# **CONNECTION ASSESSMENT & APPROVAL PROCESS**

## ***PRELIMINARY ASSESSMENT REPORT***

### ***For the Increased Supply to the Lac des Iles Mine***

***CAA ID N<sup>o</sup>. 2000-016***

Diagram 1

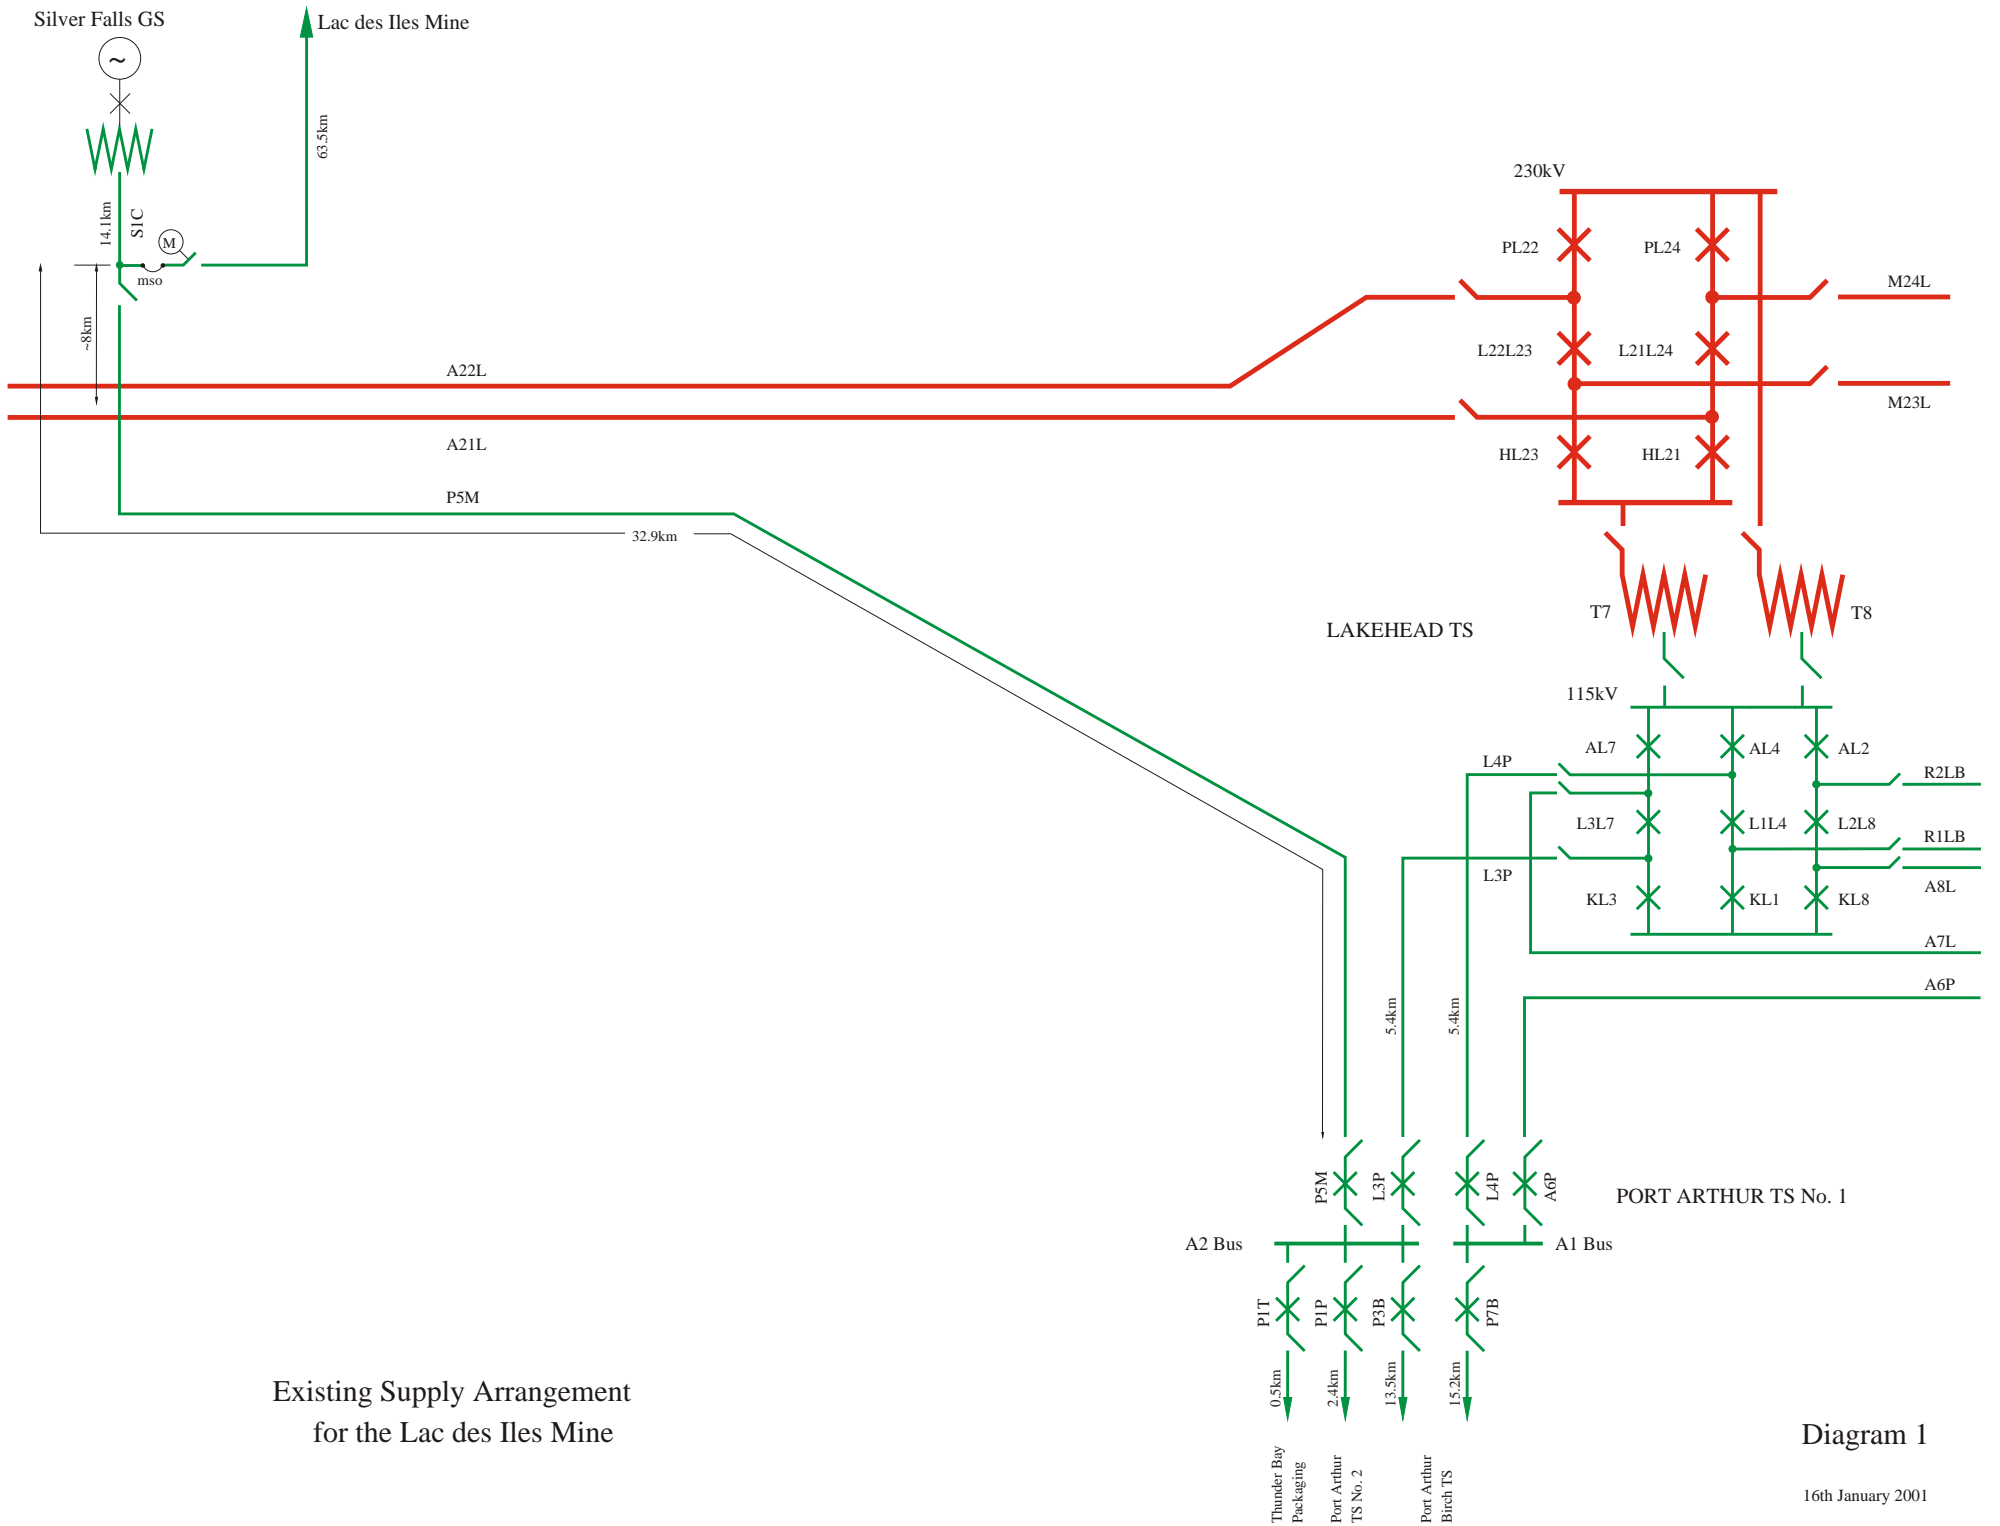
The Lac des Iles mine, northwest of Thunder Bay, is currently supplied via a privately-owned, 63.5km 115kV line that is tapped on to the 115kV circuit S1C, which together with circuit P5M, provides a direct connection between Port Arthur TS No. 1 and Silver Falls GS. The tapping point for the Lac des Iles line is approximately 33km from Port Arthur TS and 14km from Silver Falls GS. The maximum load that is presently supplied is approximately 4MW, and this includes the supply to the single 600HP synchronous motor.

Diagram 1 shows the existing supply arrangement.

Diagram 2

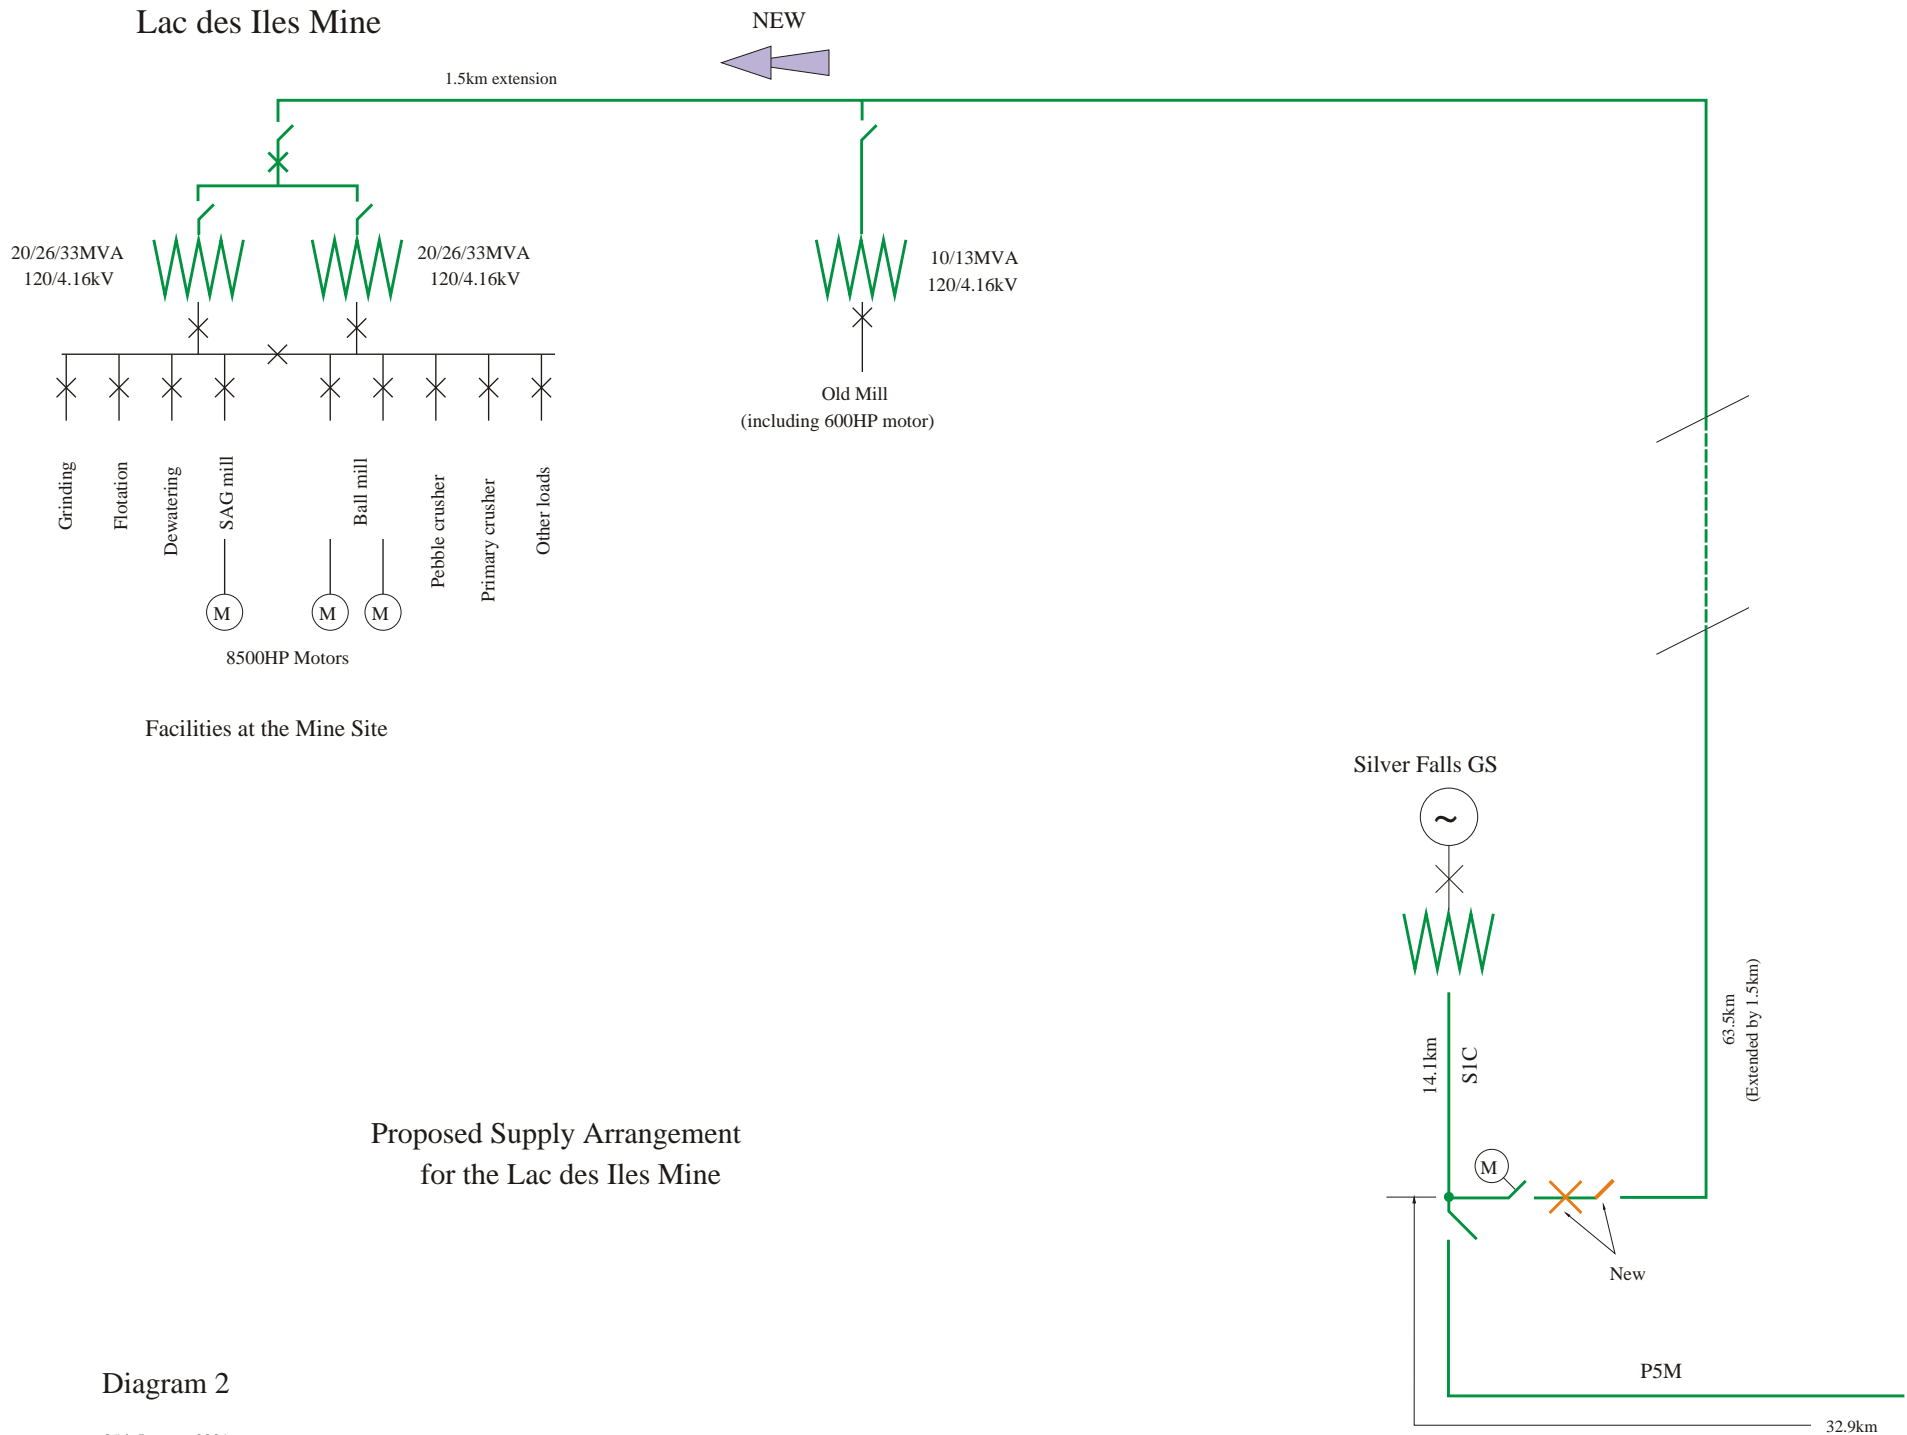
The Hydro One facilities at the point where the 115kV circuit to the Lac des Iles mine, is tapped on to the 115kV circuit S1C, are terminated at an MSO. This is connected to a motorised disconnect, which is owned by North American Palladium.

Operational difficulties have been experienced when attempting to de-energise the 63.5km line to the mine, using this disconnect. North American Palladium is therefore proposing to add a further 115kV SF<sub>6</sub> circuit breaker and a manually-operated disconnect on the line-side of the existing facilities.

Although provision has been made for the addition of line protection to the new breaker should it be required, the intention is to use the circuit breaker initially solely for 'switching' rather than for fault-interrupting duties. The role of the existing line protection will therefore remain unchanged.

At the mine site, North American Palladium is proposing to complete the following installations:

- extend the existing 115kV transmission line by 1.5km from the existing on-site substation to the new substation at the new mill.

- install a new 115kV SF<sub>6</sub> circuit breaker
- install two new 20/27/33MVA, 120/4.16kV step-down transformers
- install 4.16kV connections to the following locations:
  - the SAG mill with one 8500HP synchronous motor
  - the ball mill with two 8500HP synchronous motors

The proposed arrangement at the tapping point on to 115kV circuit P5M, and the revised arrangement at the mine site are shown in Diagram 2.
